### FIELD SAFETY NOTICES

### MAQUET CARDOIVASCULAR INFORMATION

MCV/2011-06-10/01

**Subject:** HL20 Twin Pump Module – Transient increase in pump speed  
HL20 – PSB Cover – Protection against entry of liquids

Figure 3: HL20 – 4 Pump Console (Example – identical for HL20 – 5 Pump console)  
The arrows show where the liquid can enter the HL20 Console

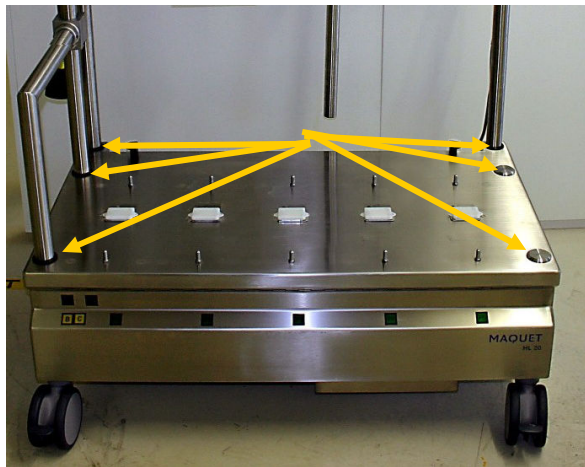
The root cause for this potential problem is, that the tolerances of the HL 20 mast diameter, the holes where the masts enter the HL 20 console (Figure 3: arrows show where the liquids can enter the HL20 Console), and the sealing rings may combine in such a way that the overall sealing effect is no longer effective in preventing liquids from entering the machine. This effect may be further compounded by additionally flushing the HL 20 System with excessive water.

All console/mast interfaces will be sealed (Figure 4: Cover Plug Sealing) and a cover (Figure 5: PSB Cover) will be mounted over the power supply board inside the HL20 console. In the very unlikely event that liquid finds its way into the console, the installation of this cover will prevent these fluids coming into contact with the power circuit board.
